# CUMNOR PARISH COUNCIL

## **BOTLEY WEST SOLAR FARM (BWSF) REF: EN010147**

### **Cumnor Parish Council's Comments for Deadline 3 on responses to Examining Authority's 1<sup>st</sup> written questions (ExQ1)**

Figure 9.1  
 reproduced from page 15 of the applicant's  
**EN010147-001239-Applicant's Change Request 2 Notification (Rev 0).pdf**  
 including the location of Upper Whitley Farm omitted from the satellite image

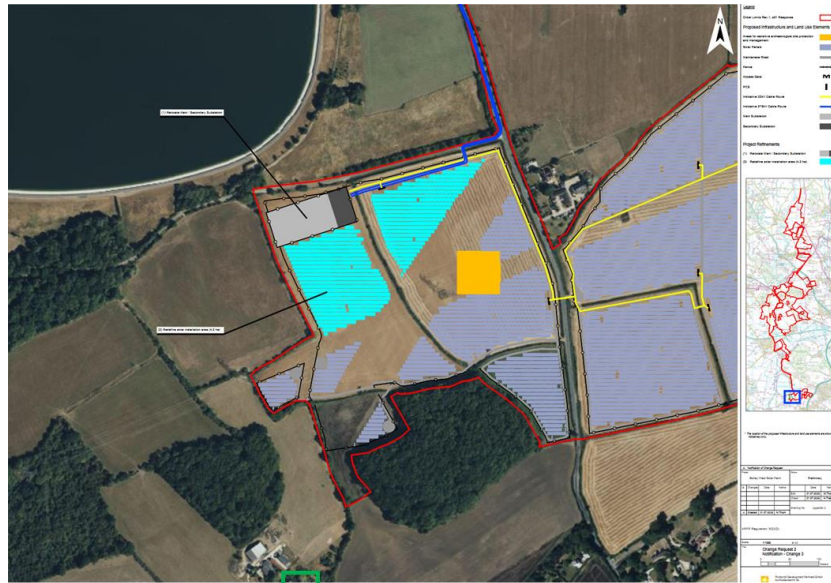
On page 80 **EN010147/EN010147-001219-12.2 Applicant's Responses to ExA's First Written Questions (ExQ1) (Rev 0).pdf** the applicant states *'No element of the Project, including the project substation, would be visible in views to or from the listed building'*

This is untrue as will be demonstrated below in Figures 9.1 and 9.2.

Furthermore, in admitting that the Grade II farmhouse's setting includes *'associated farm buildings and the land to the south-east'* and that this setting, with the Farmhouse, are *'visible in views from elevated land to the south in which the listed building is also visible.'* the applicant contradicts their own assertion that there would not be *'any change to the heritage significance of the Grade II listed Upper Whitley Farmhouse'*

This would have been apparent if the applicant had accurately described their proposed Viewpoint 51.

**CPC asks the ExA to request that the applicant produces accurate photomontages looking south and south west towards Upper Whitley Farm from the locations used for CPC's own photography in Figure 9.2 below, as the only viewpoint chosen by the applicant thus far (#50) looks ESE from a PRoW further away from the site than those now most impacted.**
